OROVILLE DAM AND RESERVOIR

REPORT ON RESERVOIR REGULATION FOR FLOOD CONTROL

Level of Flood Protection

Oroville's FIRO Space requirement

1997 120% Scaling Oroville

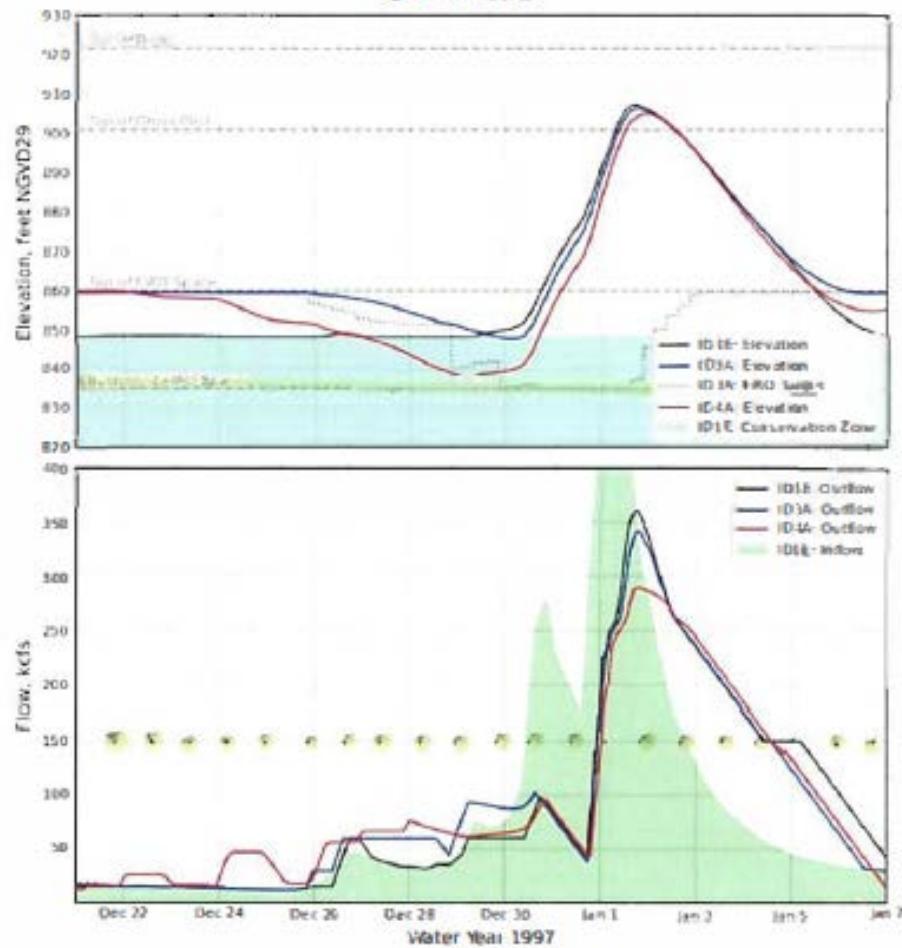
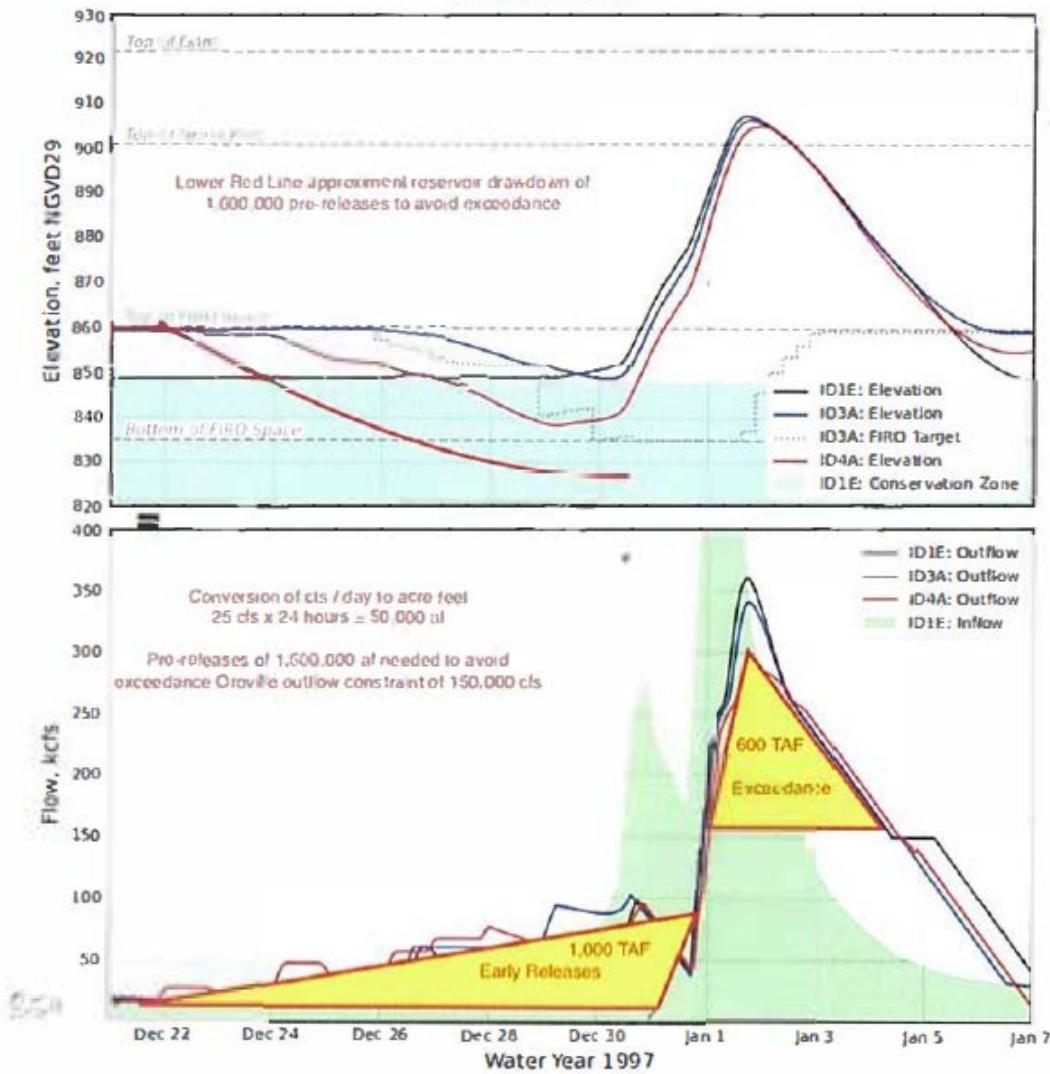
1 / 420 yr.

SPF equivalent 440K cfs peak inflows

- Surcharges Auxiliary Spillway by 5-7 ft.
- The 2017 event surcharged 20 inches
- Outflows 300-350K cfs
- Targeted outflow limit of 150K cfs

**1986 140% Scaling
Oroville**

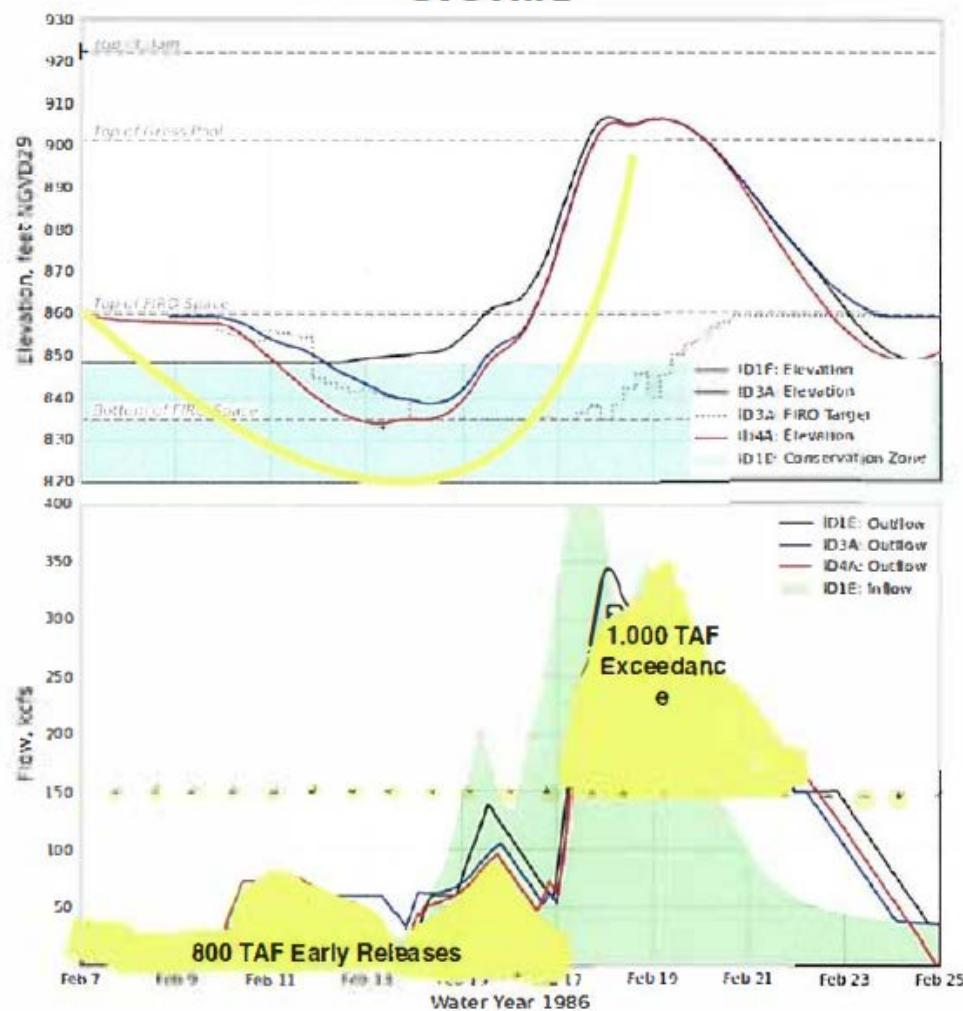
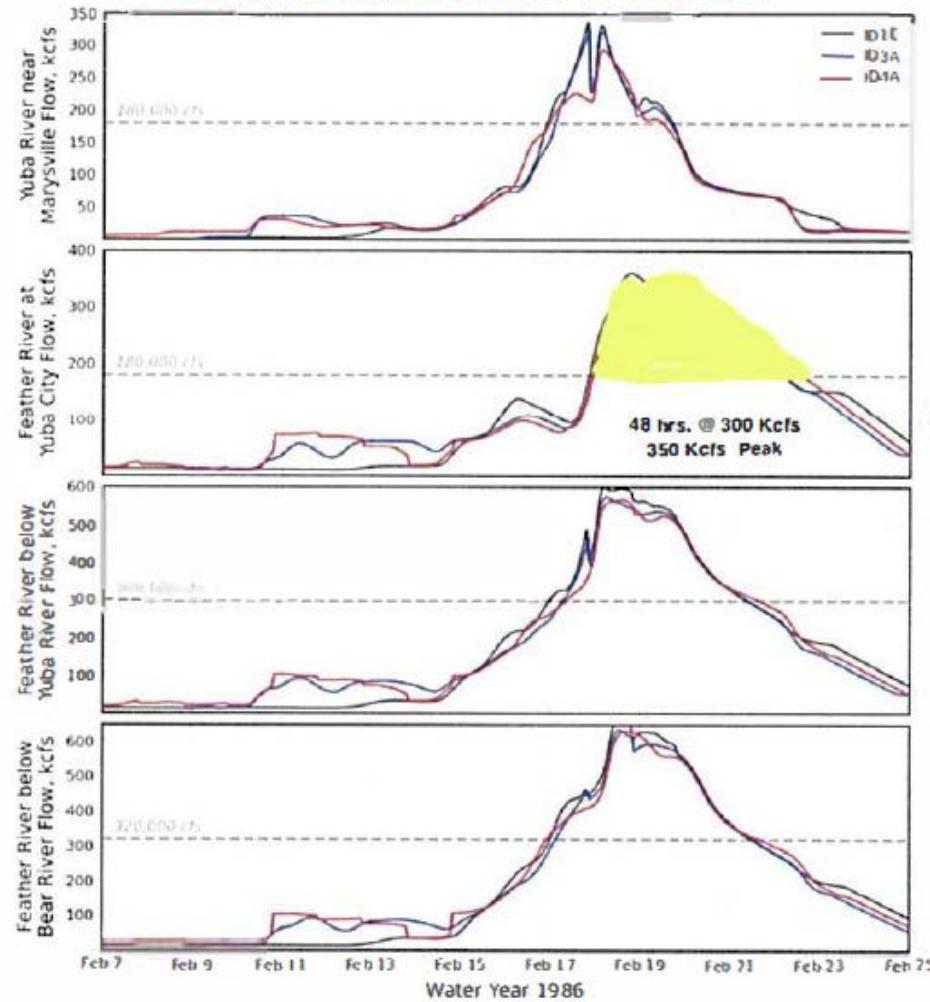
1/346 yr

City of Oroville Inundation Map

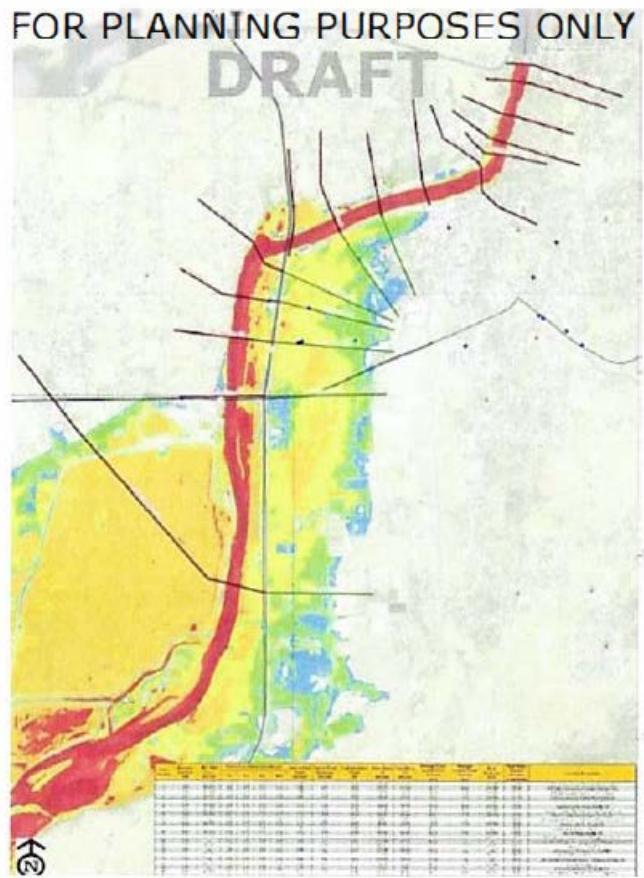
- Standard Project Flood equivalent 440K cfs inflows
- 300K cfs outflows at Oroville

2024 Spillway Performance

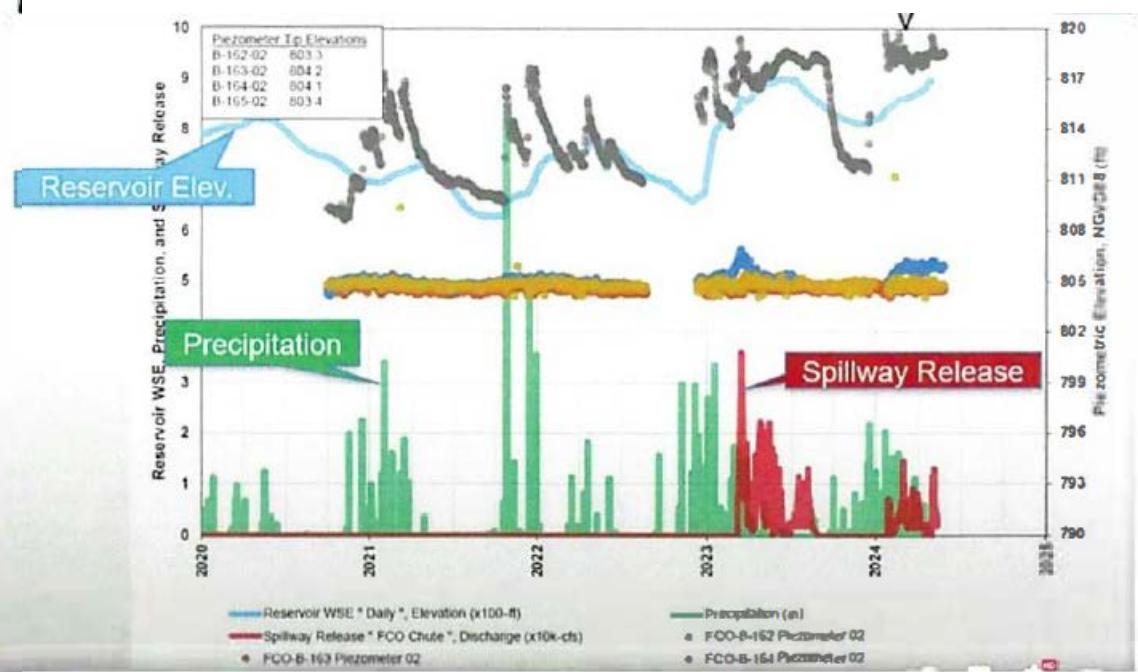
- Recovery of the conservation pool after a large event is not a concern.
- Are there infrastructure concerns when operating the FIRO space at elevation 813, bottom of the FCO-Gates?

Figure 4.10 The Inverse of AEP or Annual Return Period for Peak Total Sacramento River Flow Rate At-latitude of the City of Sacramento for Selected CVHS Flood Events

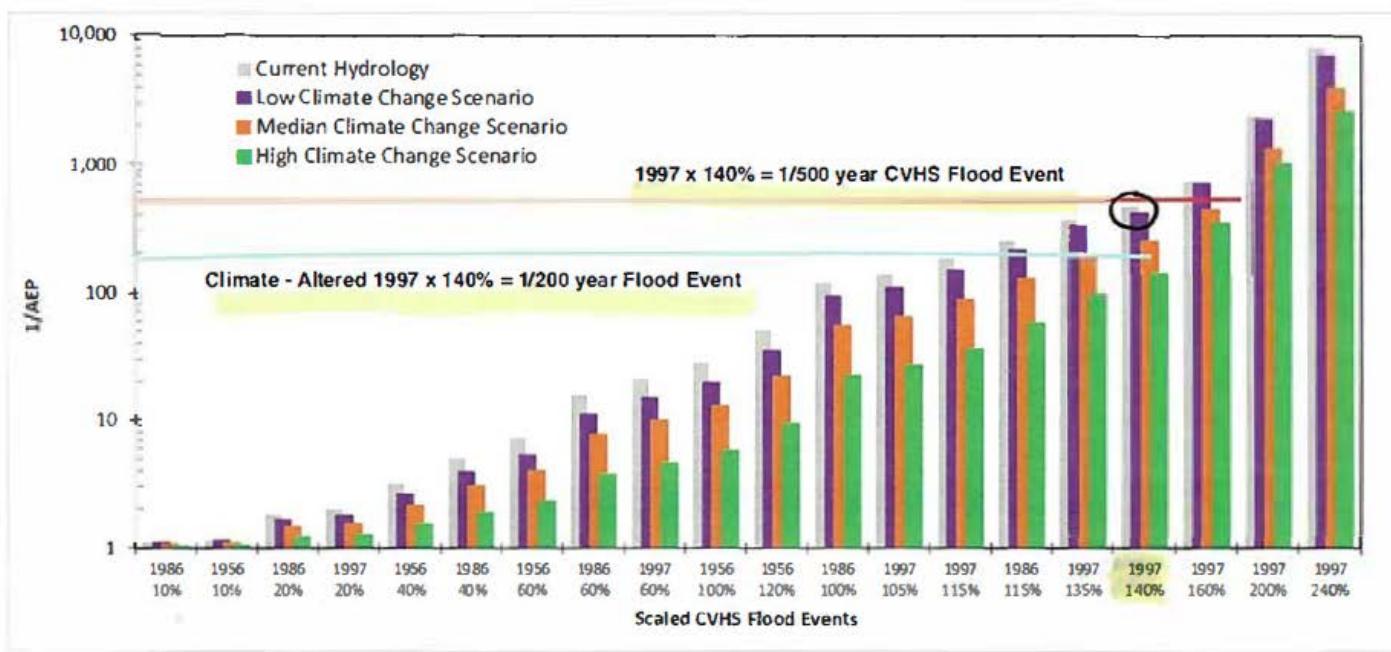
Yuba City Index SAC 25
check-climate ratios in
Appendix D

Figure 3-3. FIRO Space for ORO Reservoir.

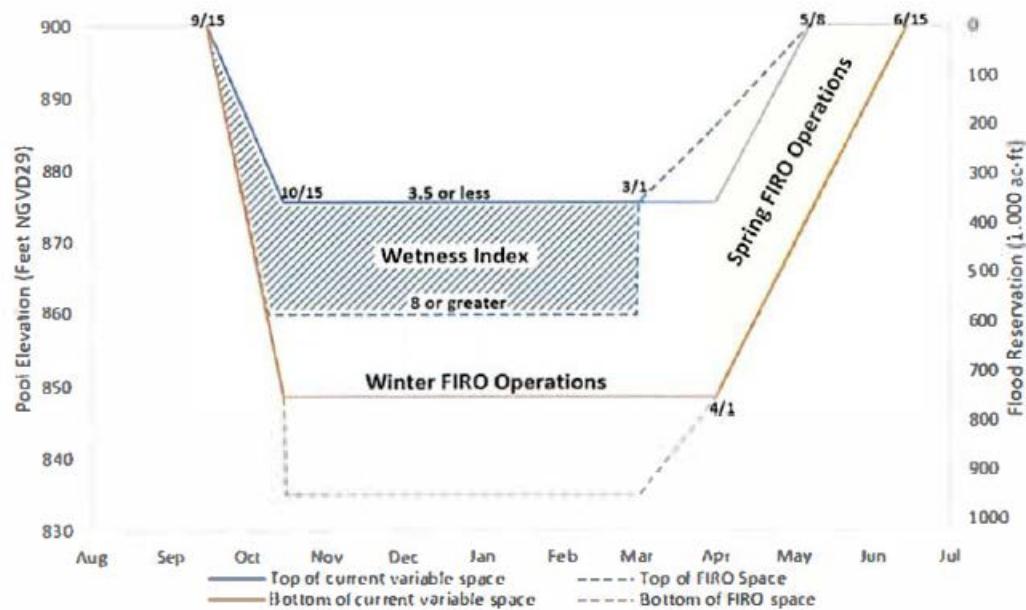
USACE Original Flood Pool 750K af

- FIRO Space 600-950K af
- Addition of Wetness Index can decrease Flood Pool to 350K af by assuming the watershed will absorb the first 250K af of precipitation
- Wetness Index does not account for the snowpacks water equivalency sitting on top of the soil

Map of wildfires in Feather River watershed

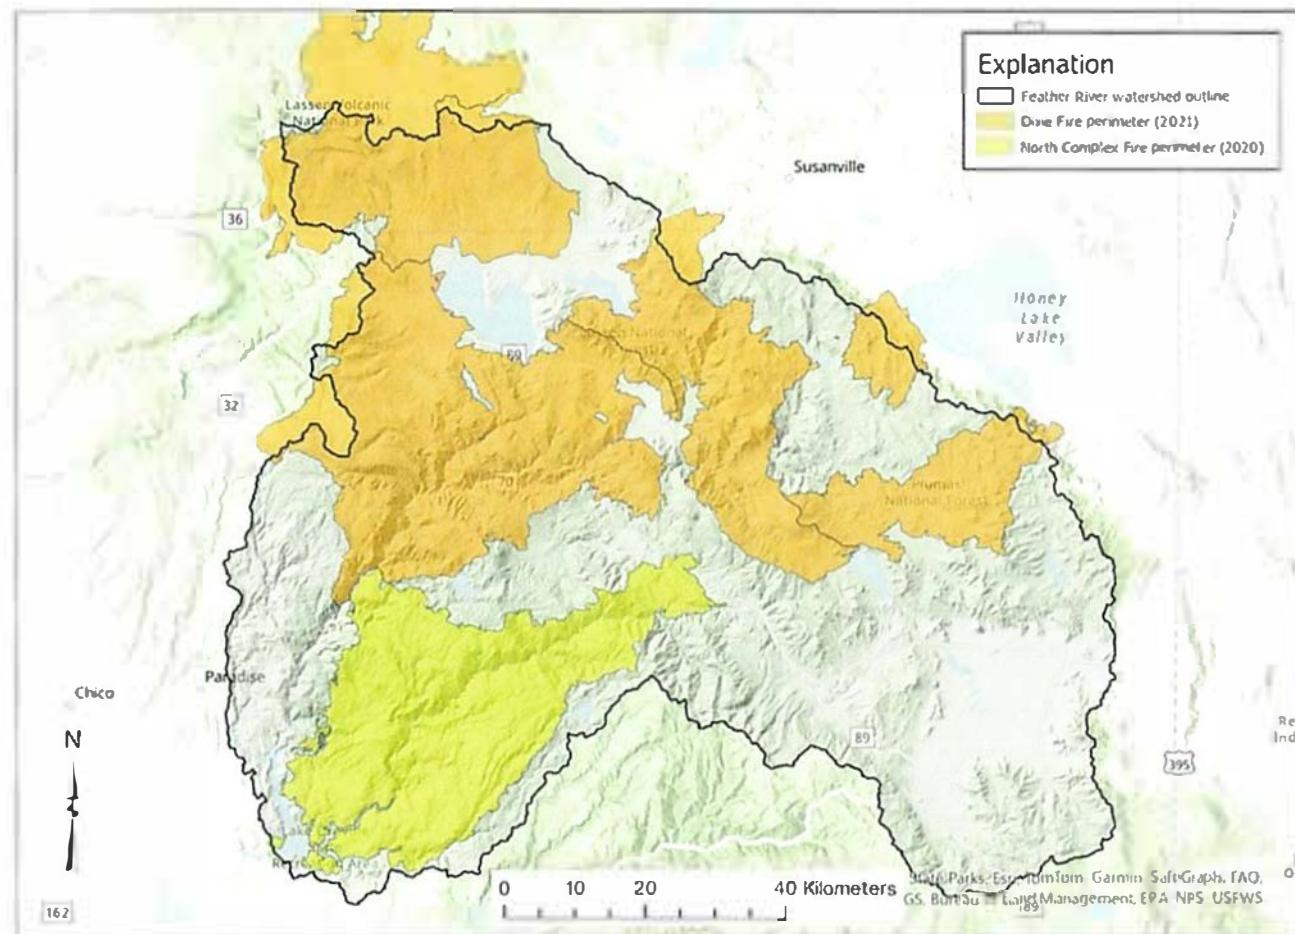
Any use of a soil wetness index should factor in the reduced soil absorption of the fire-scarred watershed.

Extreme Runoff Generation From Atmospheric River Driven Snowmelt During the 2017 Oroville Dam Spillways Incident

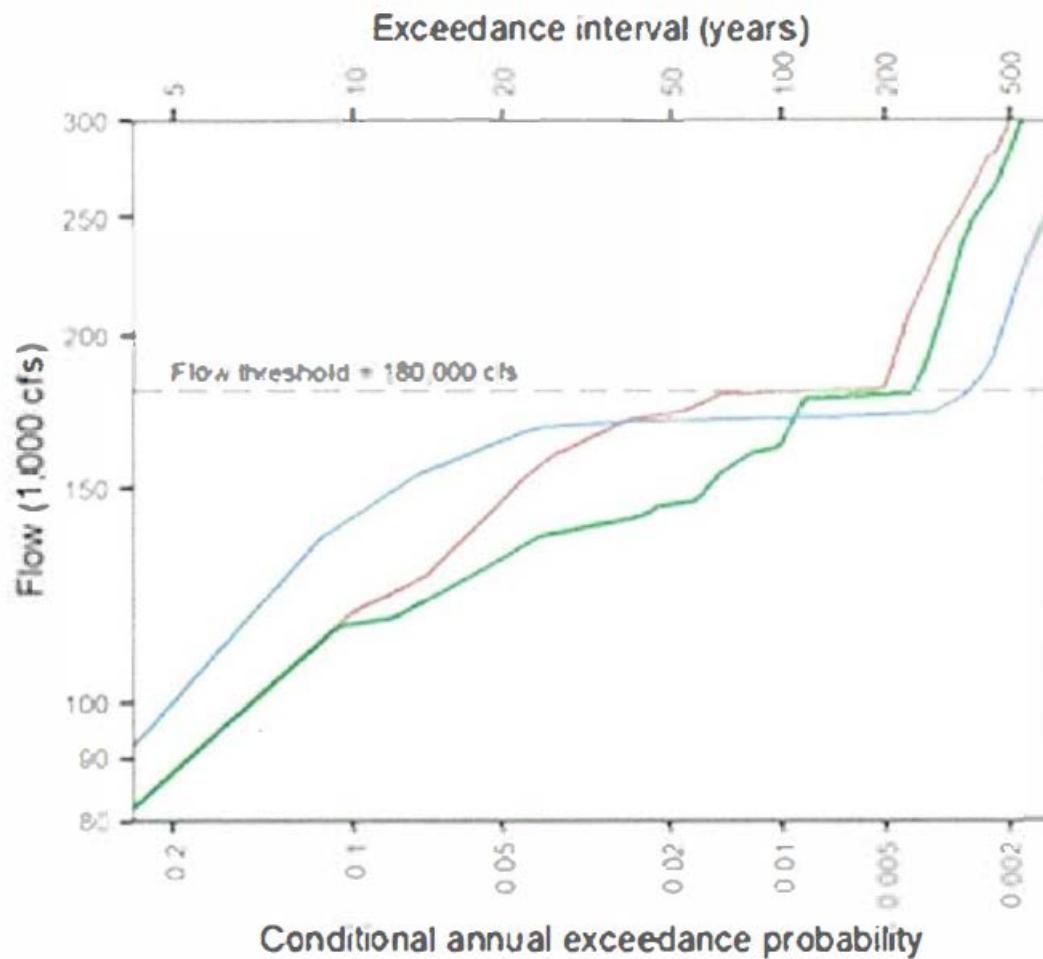
- An analysis of distributed snow water equivalency indicates that snow melt increased water available for run off - watershed wide by 37%
- Currently snow melt is not being considered in sizing of the variable FIRO flood pool
- Forecasted reservoir releases could be 37% higher on already reduced flood pool

Feather River at Yuba City

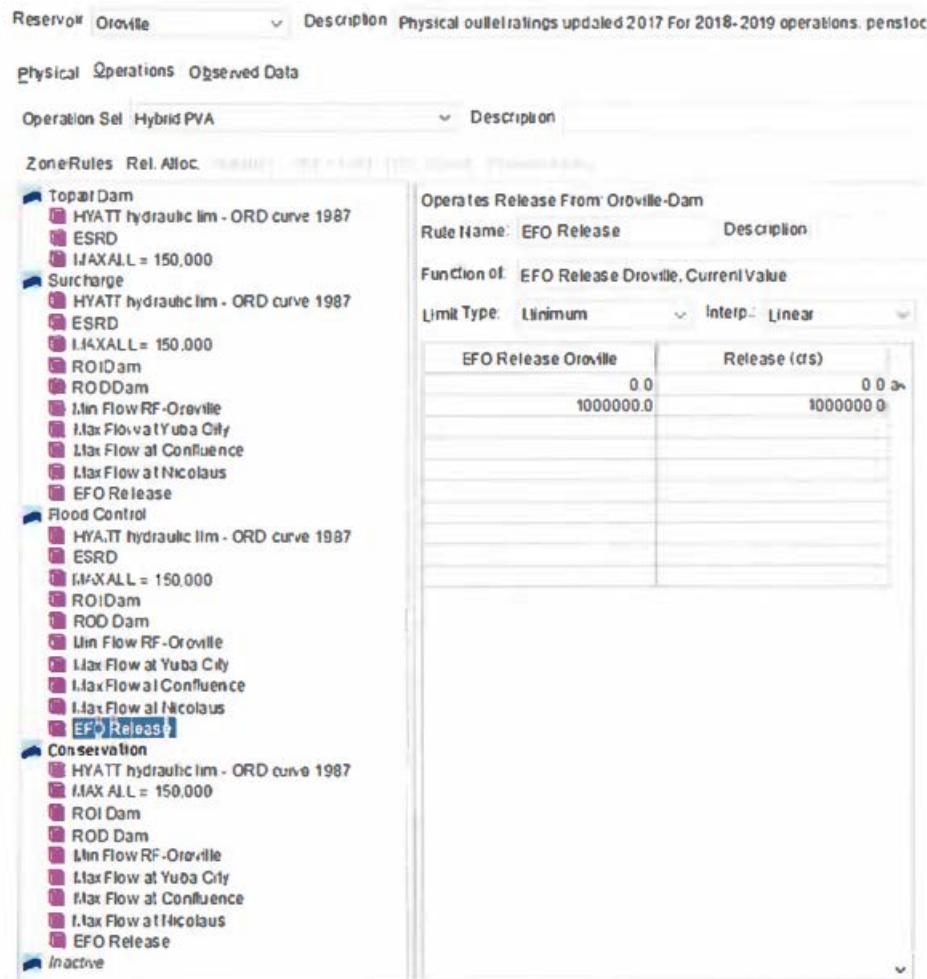
- FIRO FVA 4-3 Transfer of Benefits to Downstream Flows
- Avoid the indirect costs of downstream evacuations.
- Estimated at \$50M-\$75M during the 2017 spillway event

- Need to create a non-evacuation constraint as lower priority in the rule stack (160,000 cfs @ YC)
- Then estimate the cost of evacuation and then prioritize the rule accordingly.

Figure L-8. Frequency of end of flood season storage for Oro (top) and NBB (bottom) as a function of WCP alternative.

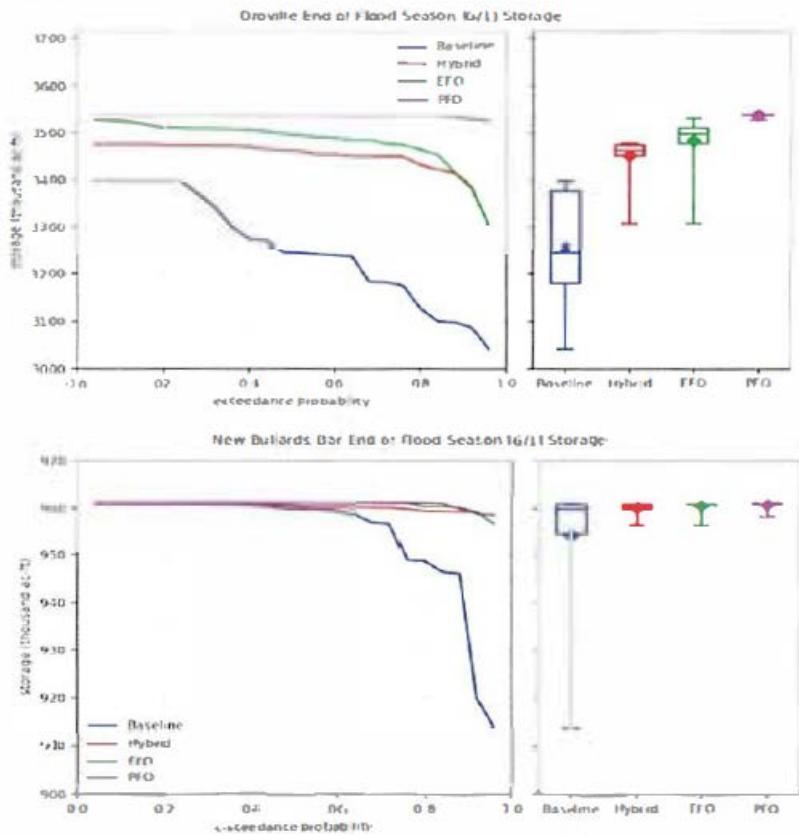
Alternative Plan	Storage Benefit
Plan ID4 to Baseline	200,000 AF
Plan ID3 to Baseline	220,000 AF

Estimated value of stored water \$1000/AF
200,000 AF x \$1000 = \$200M annual benefit
(Annual benefit over 5 years equals \$1 billion)
